IEEE P802.15
Wireless Personal Area Networks

Project	IEEE P802.15 Working Group for Wireless Personal Area Networks (WPANs)	
Title	Power Management Message Sequence Charts	
Date Submitted	2 November, 2001	
Source	Jay Bain Time Domain7057 Old Madison Pike Huntsville, AL 35801	Voice: 256 922-9229 Fax: 256 922-0837 E-mail: jay.bain@timedomain.com
	Mark E. Schrader Eastman Kodak Co. 4545 East River Road Rochester, NY 14650-0898	Voice: 716-781-9561 FAX: 716-781-9533 E-Mail: mark.e.schrader@kodak.com
Re:	IEEE Draft P802.15.3/D0.7	
Abstract	This document provides recommended message sequence charts for the power save clauses of the 802.15.3 MAC to be incorporated into D0.8	
Purpose	The recommendations contained in this document are to be applied to the 802.15.3 MAC baseline, in conjunction with document 01/485r3 CTA Changes for Power Management and Resynchronization	
Notice	This document has been prepared to assist the IEEE P802.15. It is offered as a basis for discussion and is not binding on the contributing individual(s) or organization(s). The material in this document is subject to change in form and content after further study. The contributor(s) reserve(s) the right to add, amend

Figure 64 - Operation of EPS mode channel time requests

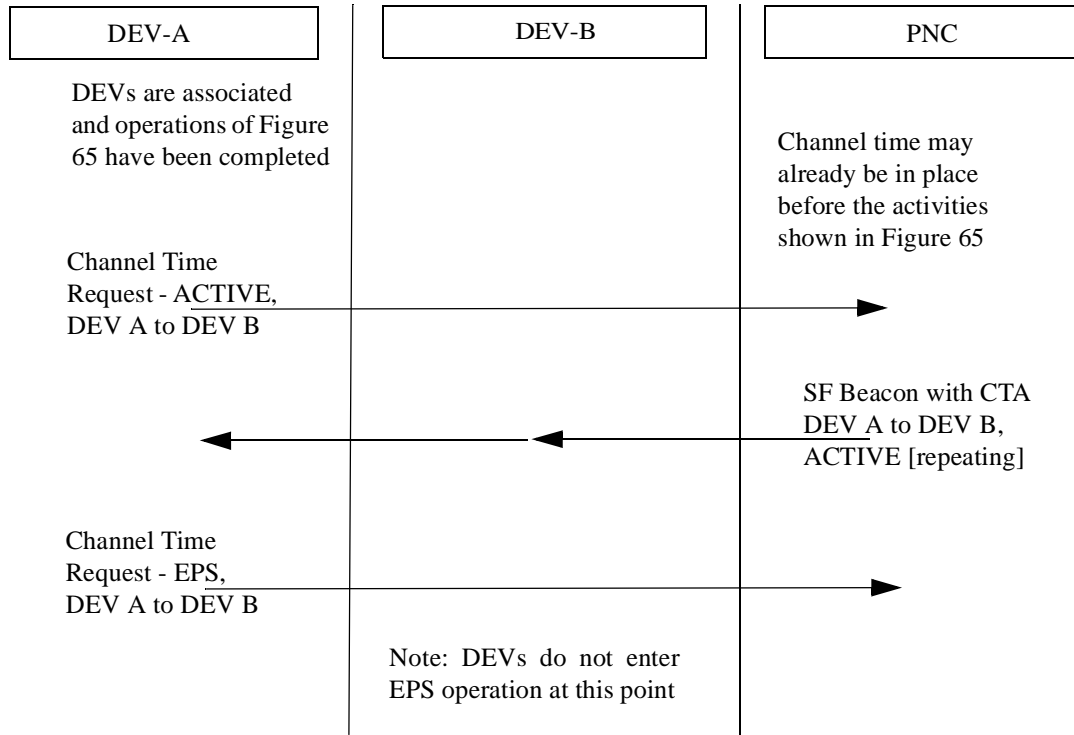
This is the first graphic and covers the channel time request process for DEVs that will operate in EPS mode.

Figure xx - Operation of EPS mode switching

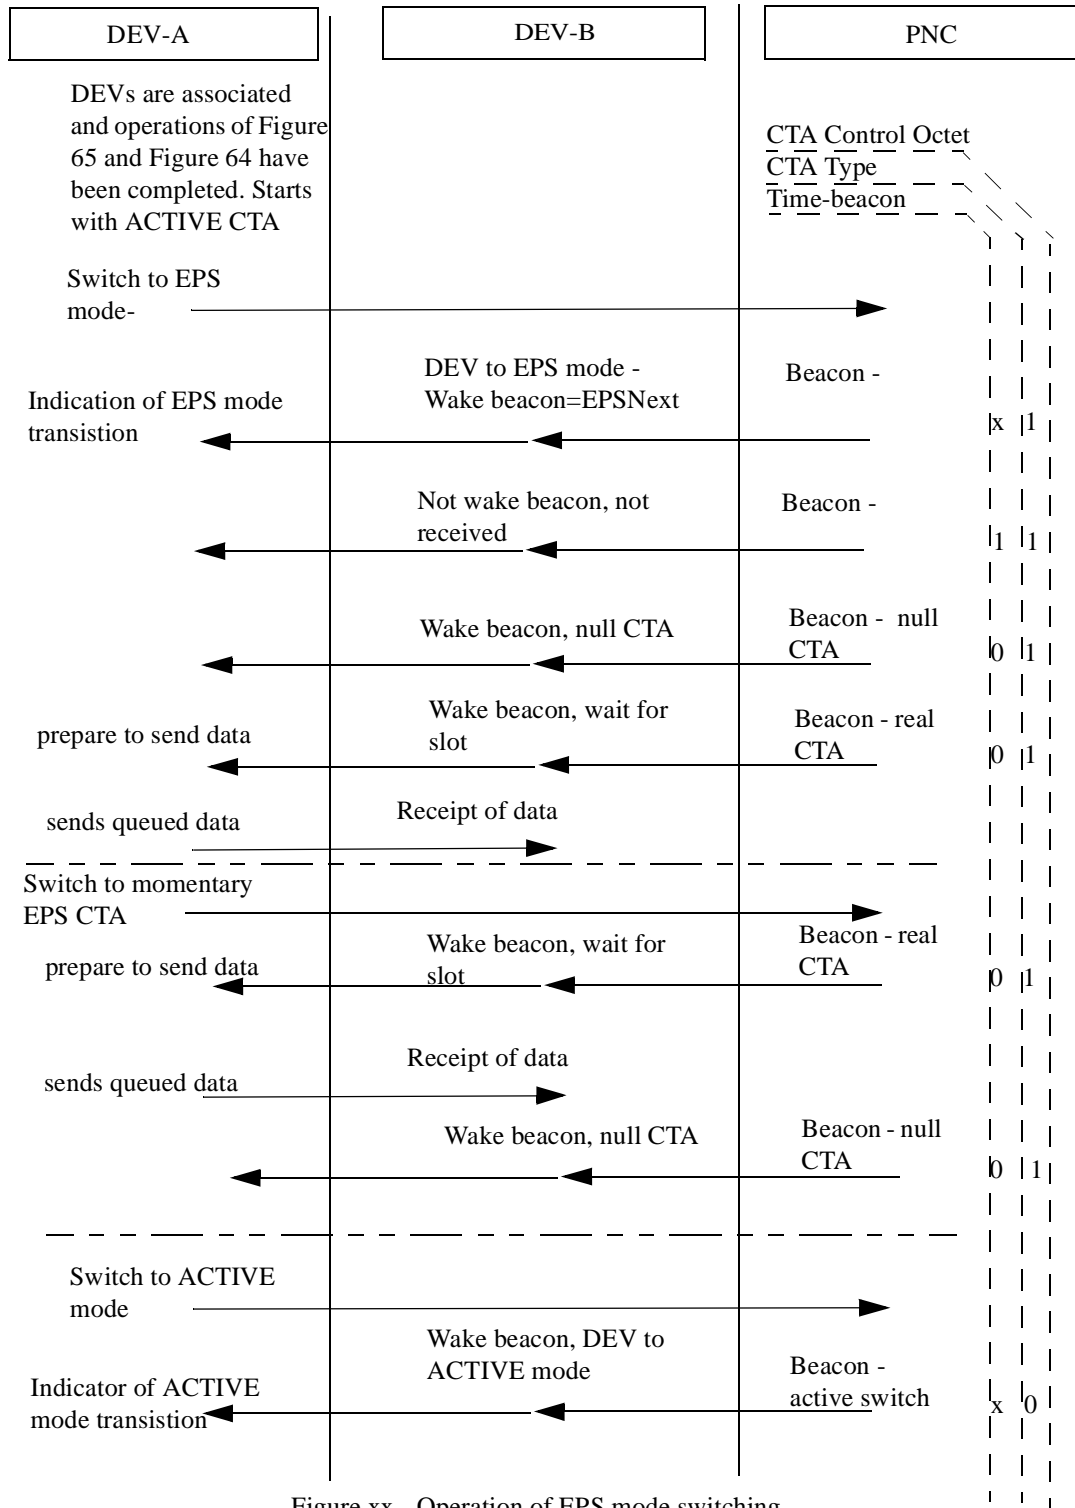
This next graphic is the message sequence chart for the control sequences for EPS, ACTIVE, and the use of momentary

Figure 65 - Illustration of the EPS control process

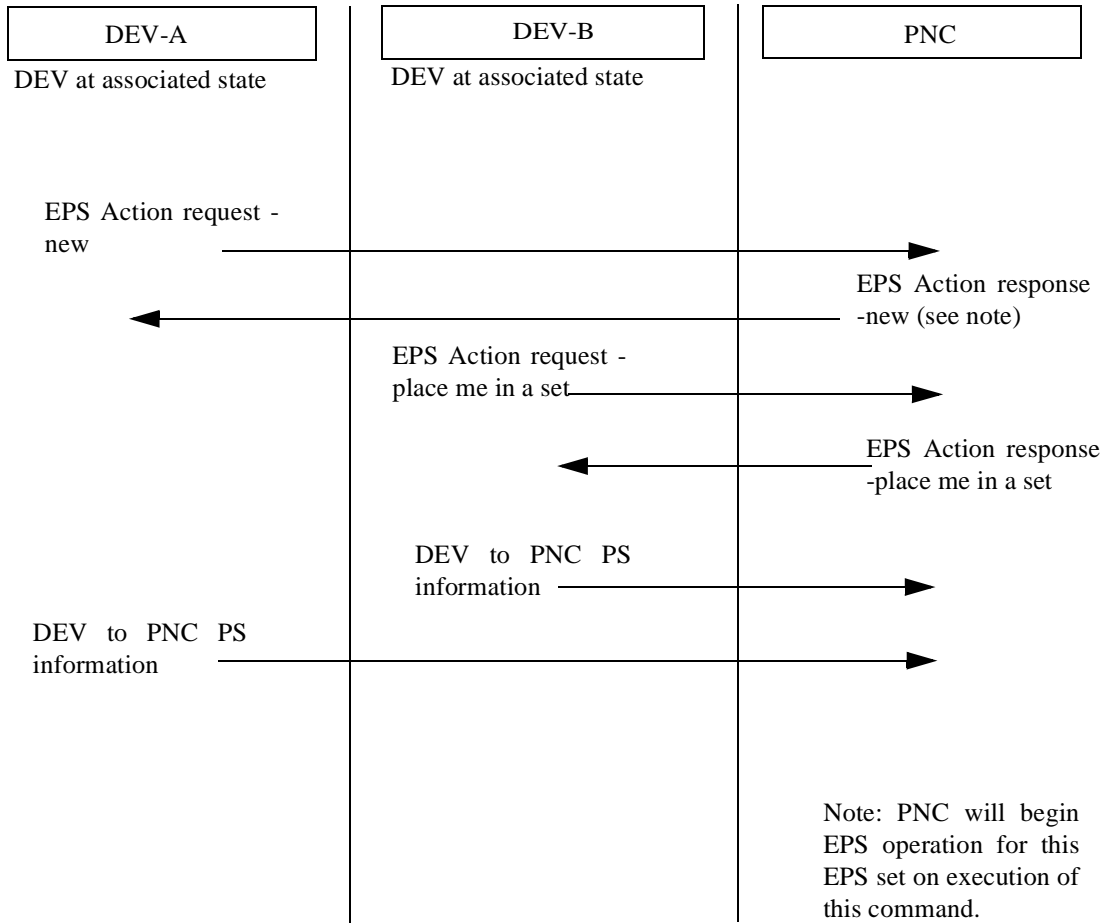
the following is the message sequence chart for initial setup of EPS DEVs and is placed in clause 8.12.3.3
